TO: Bob Exstrom, Town of Parker
FROM: Stacey Nerger, Senior Planner
DATE: February 29, 2024
SUBJECT: Parker Town Hall Amendment 3 Lot 1 – Site Plan
Review Comments 02

Parker Town Hall Expansion

PARKER TOWN HALL EXEMPTION PLAN AMD3 L1 SITE PLAN SUBMITTAL

EXTERIOR ELEVATION - WEST

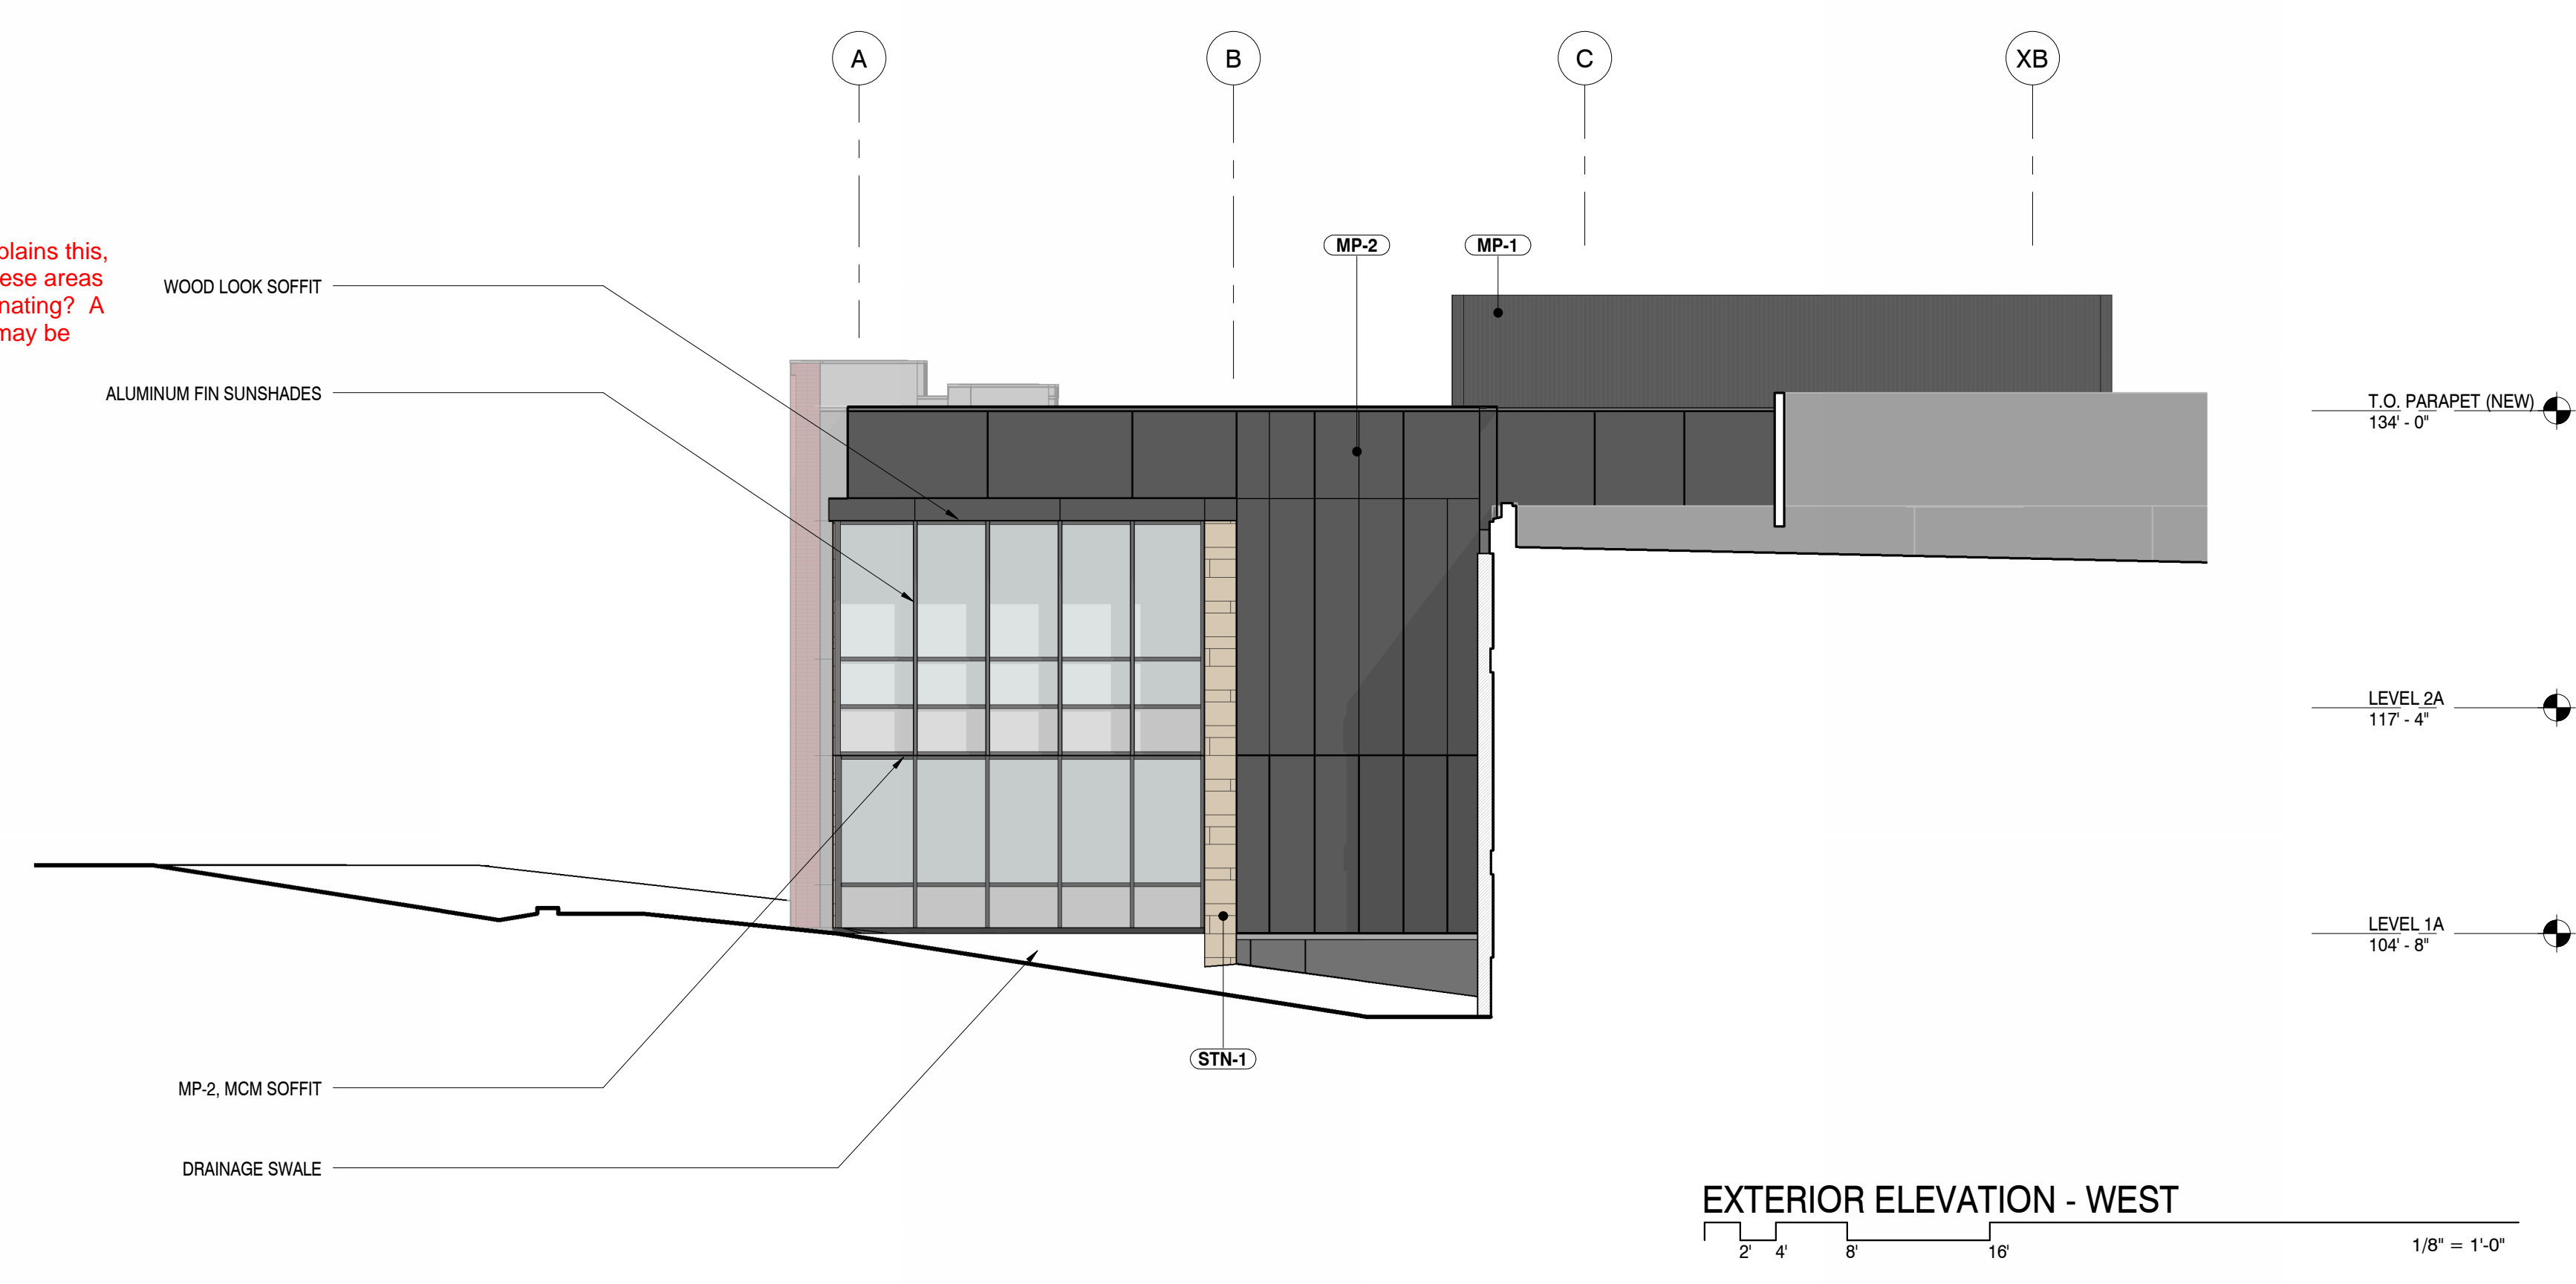
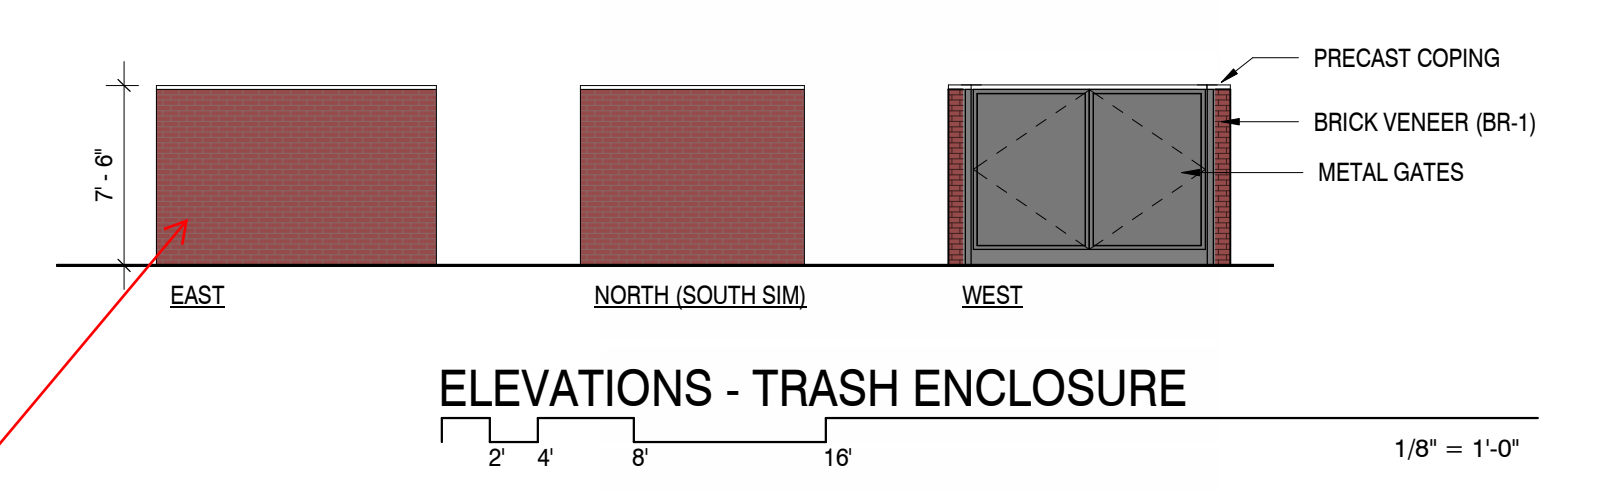
If using the sawtooth as mentioned above can be done, it would also look really nice along this edge as well.
